# *Proposed Flood Resilience Text Amendment*

**PROPOSED "A TEXT" AMENDMENTS**

# OUTLINE OF PROPOSED CHANGES

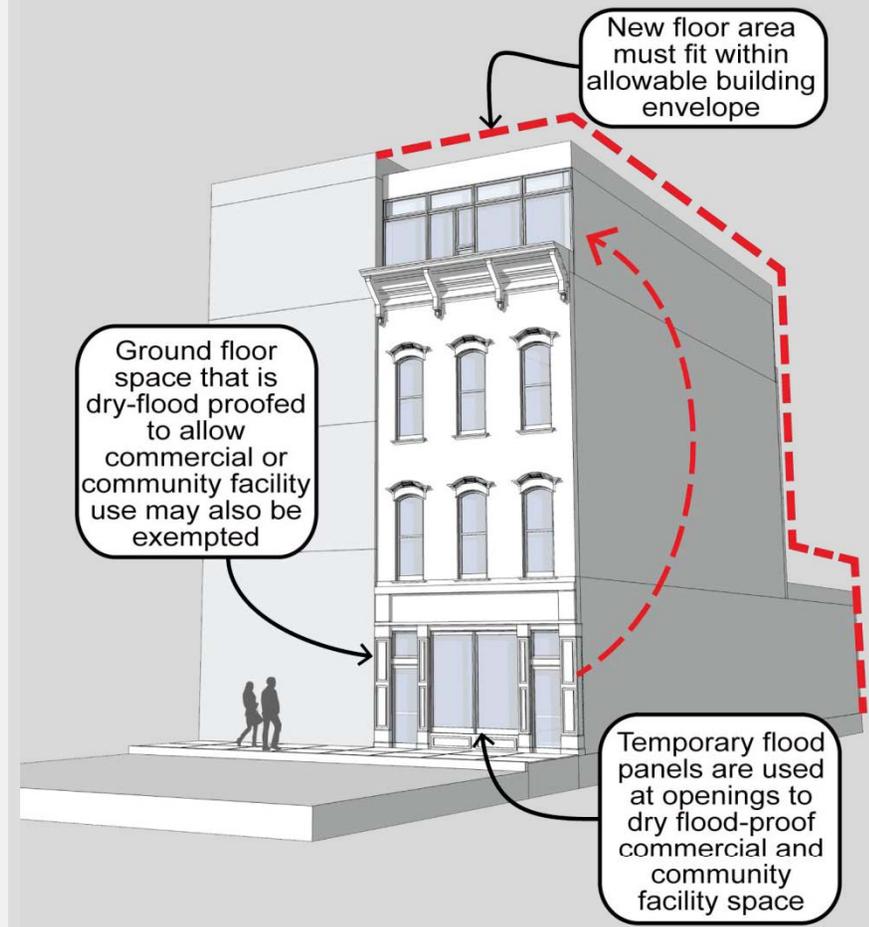
Allow building owners to recapture floor space made unusable due to compliance with the Building Code's wet-flood proofing standards.

To encourage active commercial streets, in low density commercial districts, allow building owners to exempt ground-level commercial or community facility floor area that is dry flood-proofed.

- Available only in commercial districts with an R6 or less residential equivalent

# FLOOD PANELS IN WATERFRONT YARDS, PUBLIC PLAZAS, AND OTHER PUBLIC AREAS

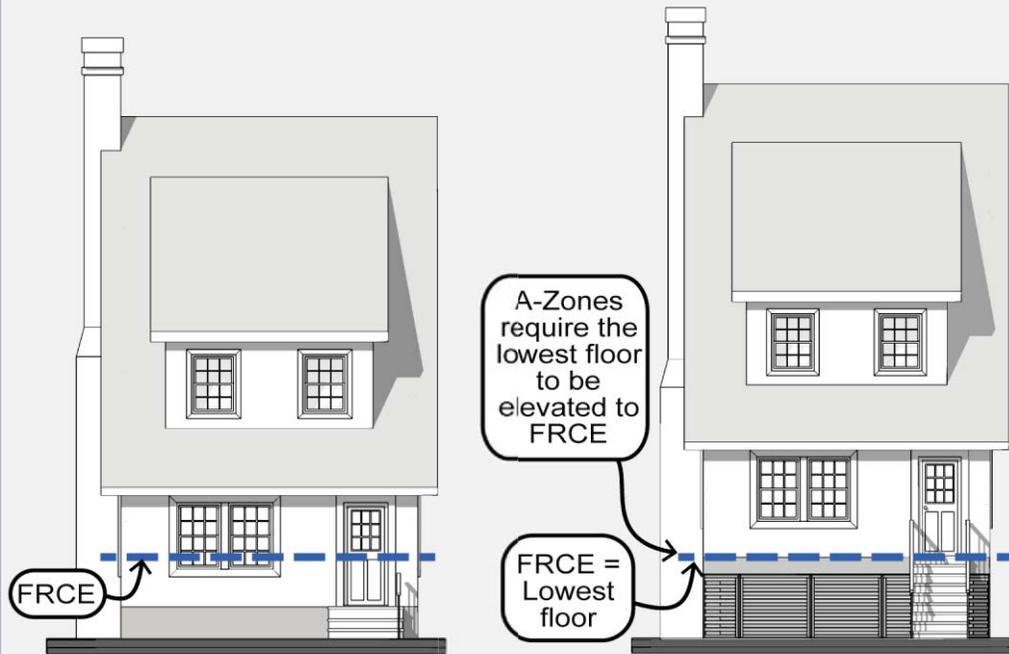
Deployable flood panels are allowed in yards, courts, and open space, but are not allowed in waterfront yards, public plazas or other public areas.

Allow deployable flood panels within waterfront yards, public plazas or other public areas as permitted obstructions.

Lowest structural member elevated to FRCE in V-Zone

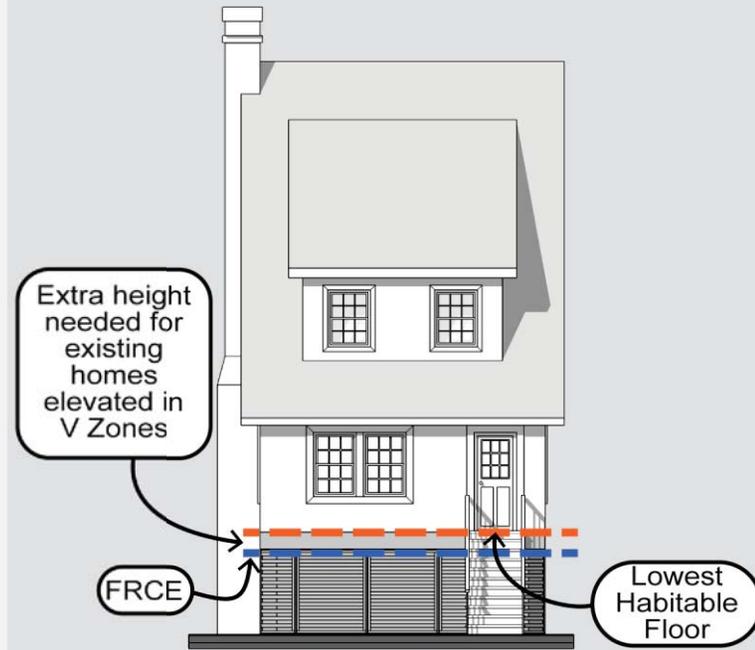
Allows existing homes to elevate to the extent necessary to lift the lowest habitable floor above grade to the FRCE, even if new non-compliances are created.

In V Zones, flood resistant standards require that the bottom of the lowest horizontal structural member be elevated to the FRCE.

Allow existing homes in V zones to elevate to the extent necessary to lift the bottom of the lowest horizontal structural member to the FRCE, even if new non-compliances are created.

This will allow an existing home to maintain the same square footage and height that existed prior to the storm.

# TIME LIMIT TO REBUILD EXISTING 1 & 2 FAMILY HOUSES

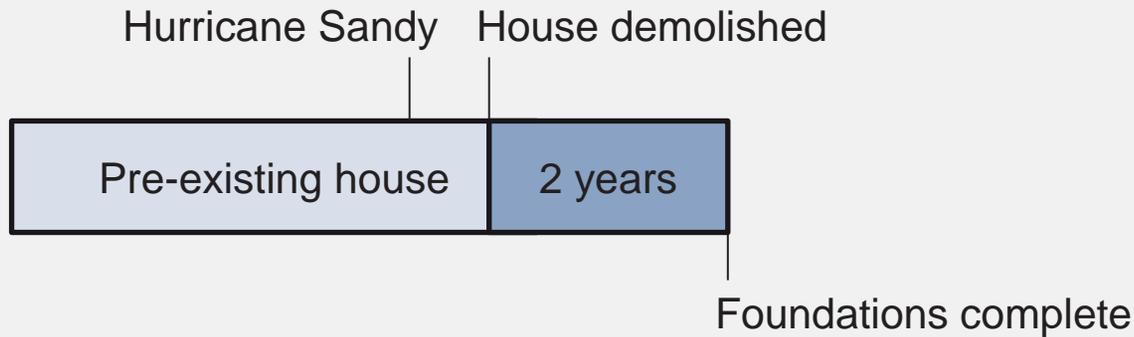
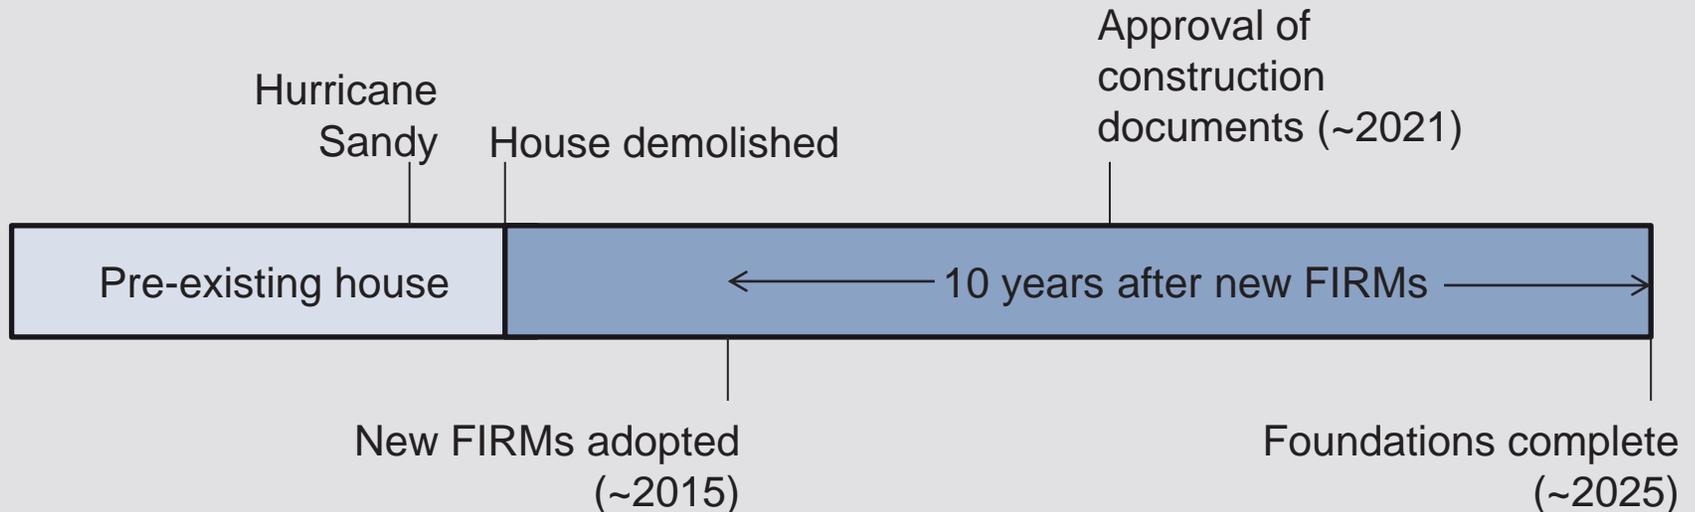
By interpretation, the Department of Buildings limits the opportunity to vest the replacement of a destroyed single- or two-family building with an equivalent house to two years.

Within the flood zone, extend the time limit to vest a replacement of a destroyed or demolished single- or two-family building to ten years after the adoption of new FIRMs (ten years after 2015).

# STREETSCAPE STANDARDS FOR SINGLE- AND TWO-FAMILY HOMES IN R6 DISTRICTS

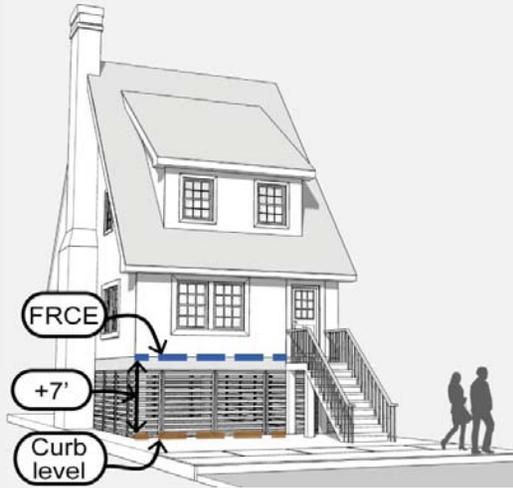
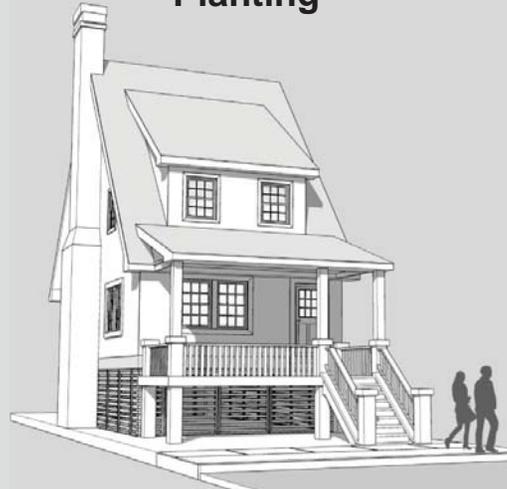
No standards for detached and semi-detached buildings in R6 Districts.

Apply standards to detached and semi-detached homes in R6 Districts

- When lowest floor is located 5–9 feet above curb level, choose 1
- When lowest floor is 9 feet or more above curb level, choose 2

# BALCONY AND TRELLIS

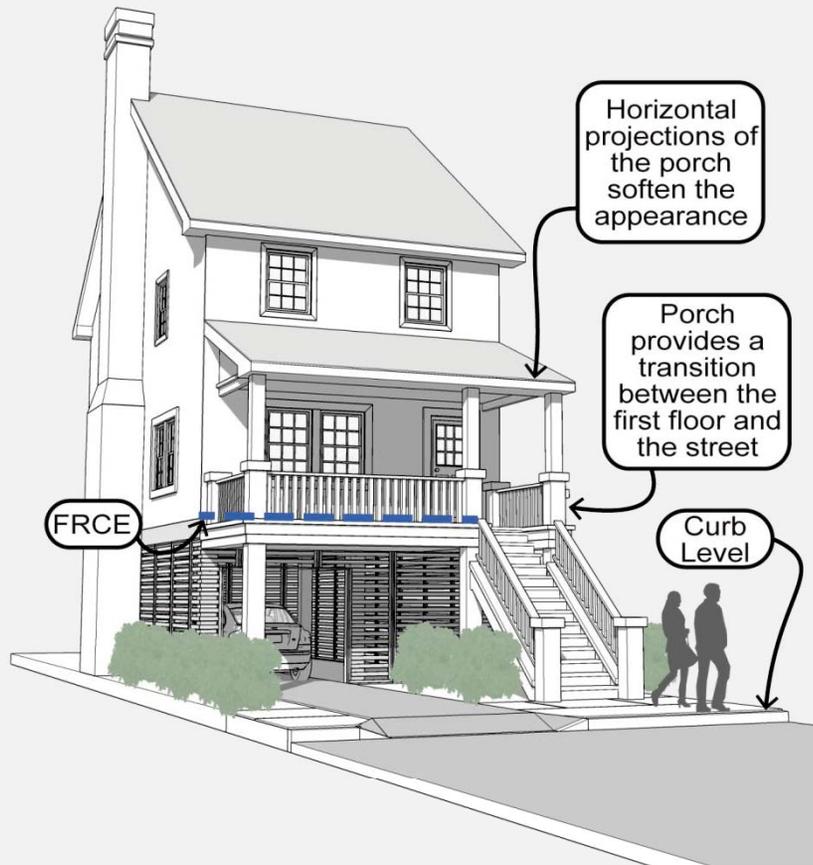
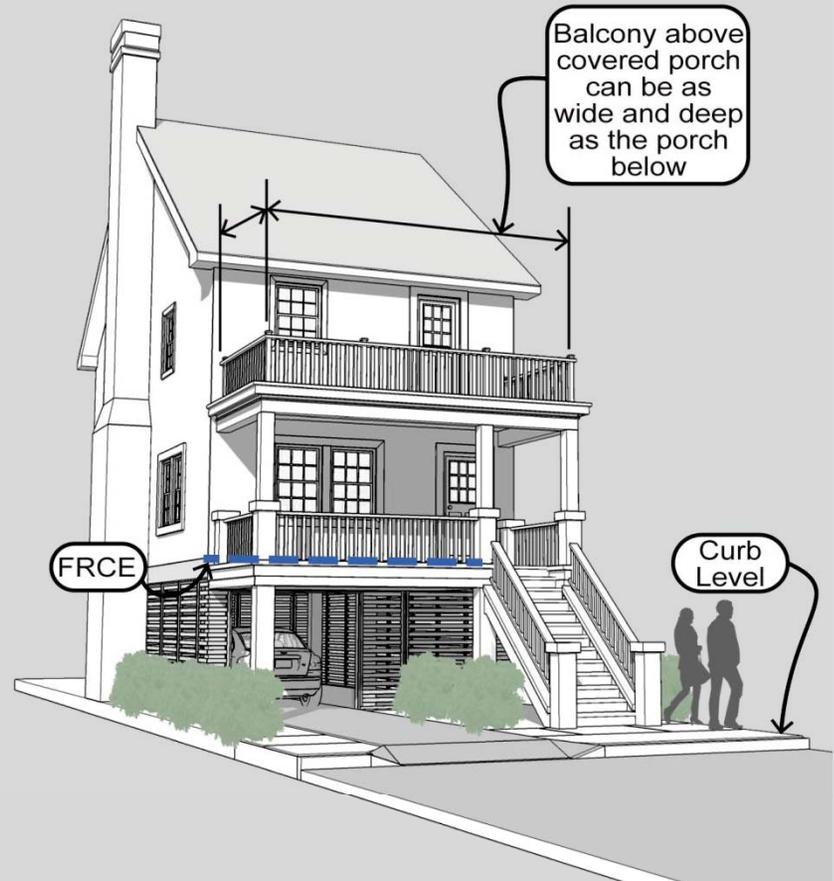
Currently limits the types of covered porches that may be provided and limits balconies to 50% of the width of the street wall.

For additional design flexibility, allow trellis roofs to count as covered porches and allow additional width for balconies to extend up to the width and depth of the porch below.

# PLANTING REQUIREMENT FOR MULTI-FAMILY AND COMMUNITY FACILITY BUILDINGS IN RESIDENCE DISTRICTS

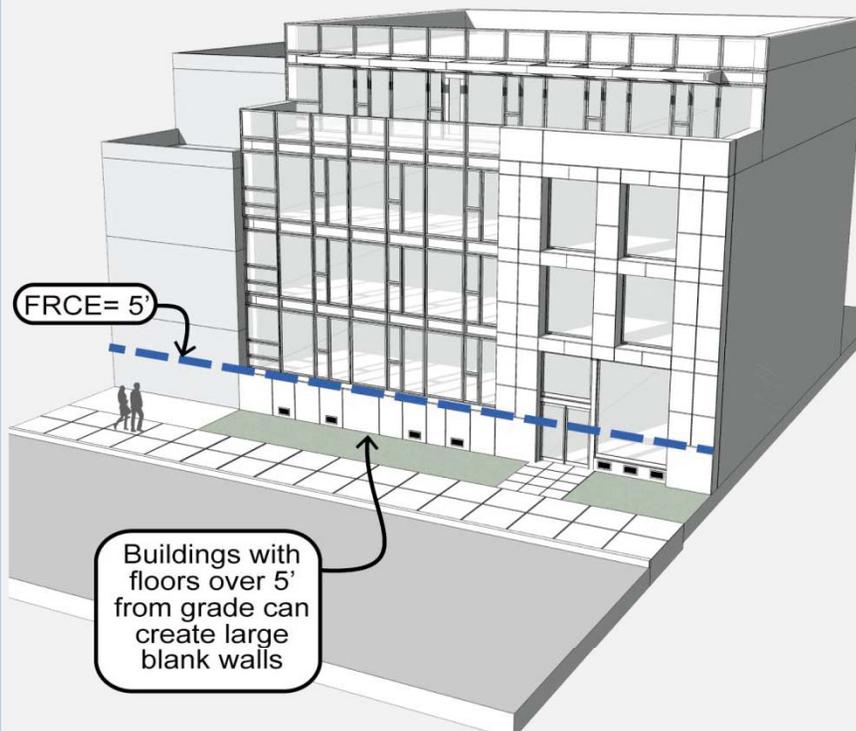
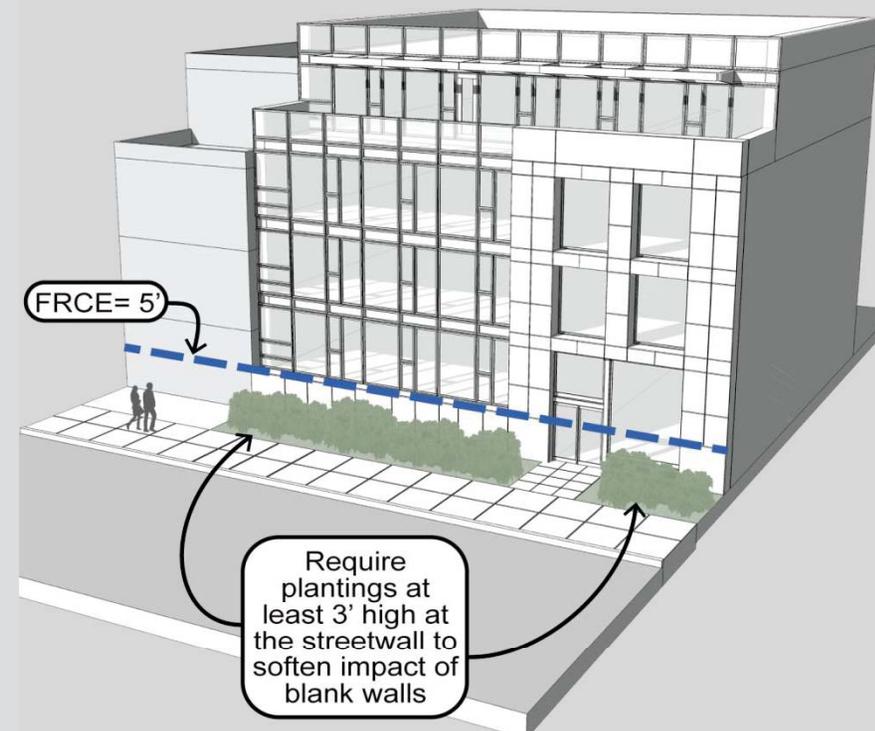
For new or elevated buildings where the FRCE is 5 to 10 feet above grade, blank walls are likely.

The original proposal only imposes streetscape standards for these building types when the FRCE is 10 or more feet above grade.

Establish planting requirements where the FRCE is 5 or more feet above grade for all new or elevated multi-family and community facility buildings.

- Does not apply to industrial uses
- Does not apply to buildings that are required to be less than 3 feet from the street line

# BULKHEAD ALLOWANCE FOR SMALL MULTI-FAMILY LOTS IN R3-2 & R4 DISTRICTS

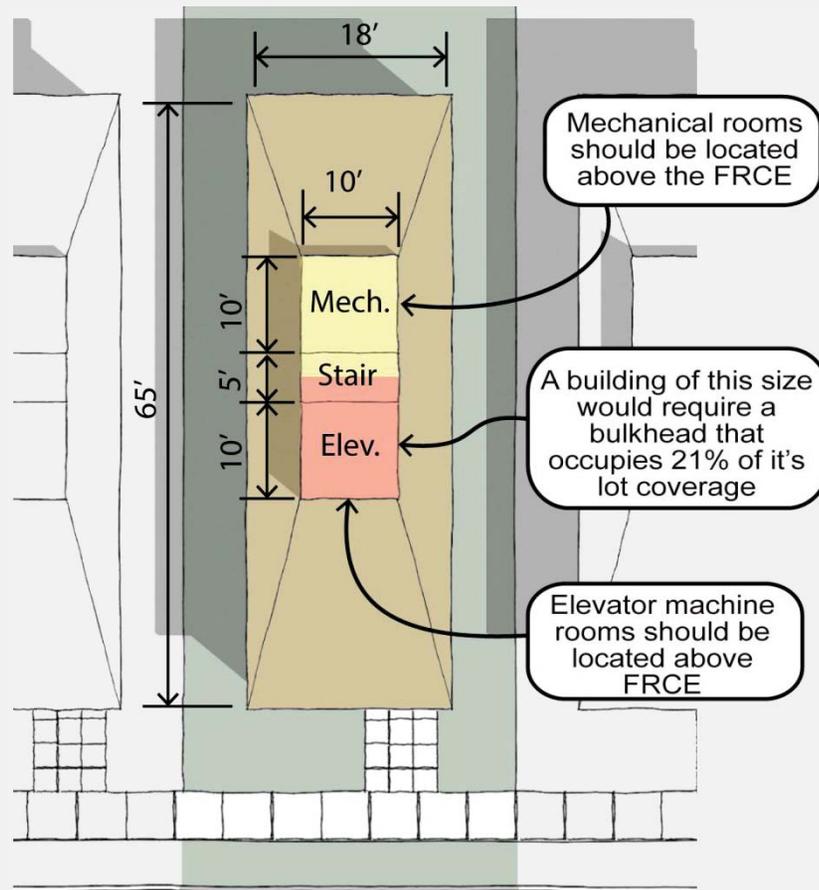
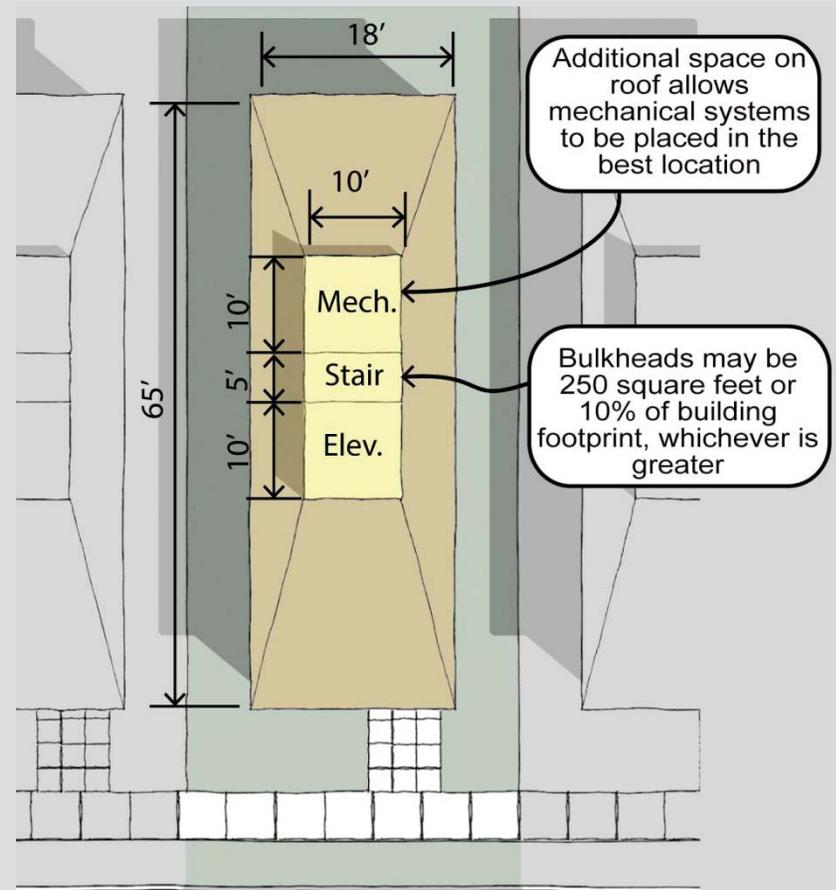
Allow elevator, stair and mechanical bulkheads in apartment buildings to exceed height limits, limited to 10% of the building footprint.

For small buildings, 10% does not allow reasonably sized bulkheads.

Allow up to 250 square feet, or 10% of building lot coverage, whichever is greater so that smaller buildings can provide reasonable bulkheads.

# ABOVE DETACHED GARAGES FOR EXISTING 1 & 2 FAMILY HOMES

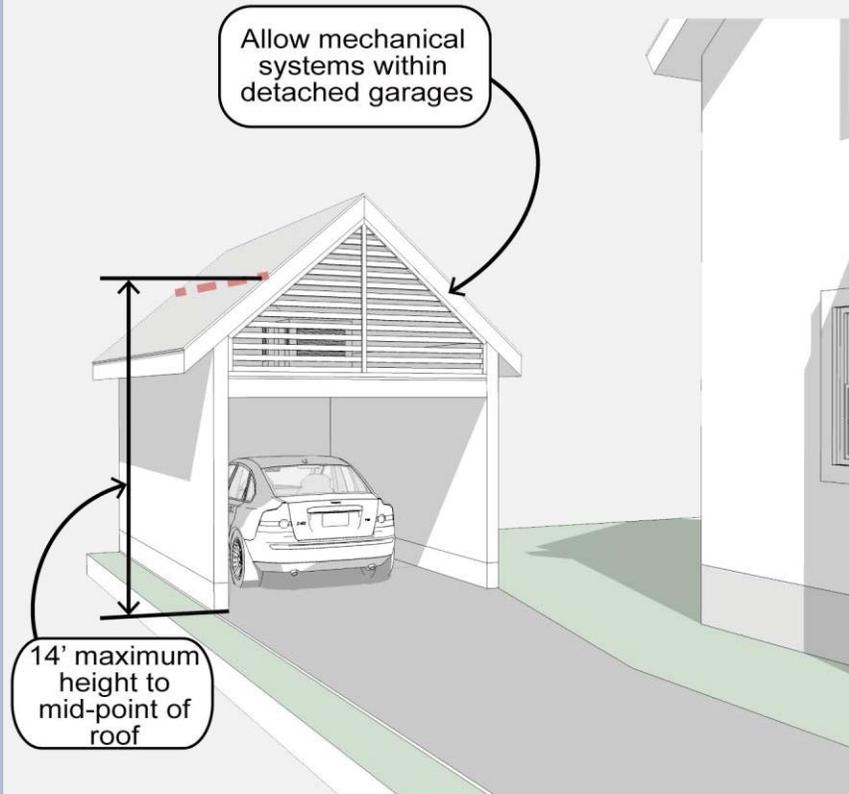
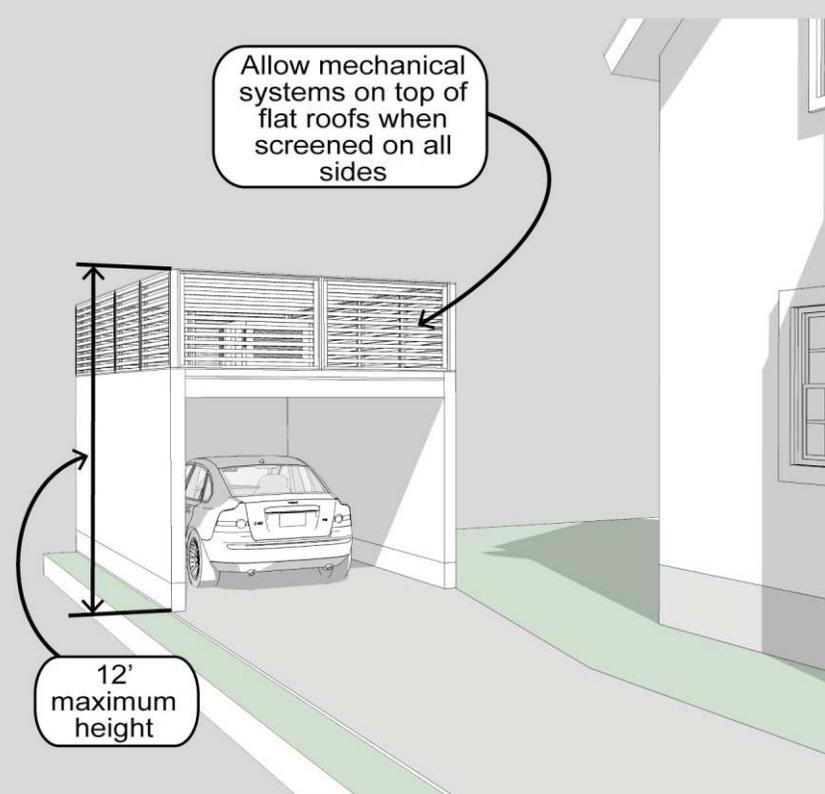
The original proposal allows accessory mechanical equipment within pitched roof accessory structures only

Additionally, allow accessory mechanical equipment on flat roofed accessory structures, when:

- equipment is screened on all sides
- Does not exceed 12 feet in height
